From: Enfinger, Timothy Lee [mailto:TLENFING@SOUTHERNCO.COM]
Sent: Monday, January 28, 2019 2:21 PM
To: Auluck, Rajender <Rajender.Auluck@nrc.gov>
Subject: [External_Sender] Hatch HCVS FIP Follow-Up

We have some supplemental information related to the Plant Hatch HCVS FIP for the staff's consideration. Can you provide us a ballpark timeframe for when review may be complete? Here is the supplemental information:

Action 3: Location of HCVS Batteries and Chargers

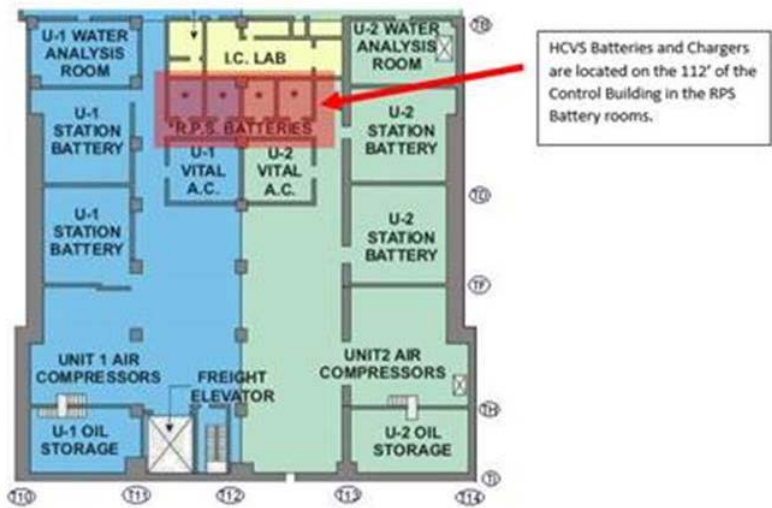
This diagram indicates the location of the HCVS batteries and chargers.
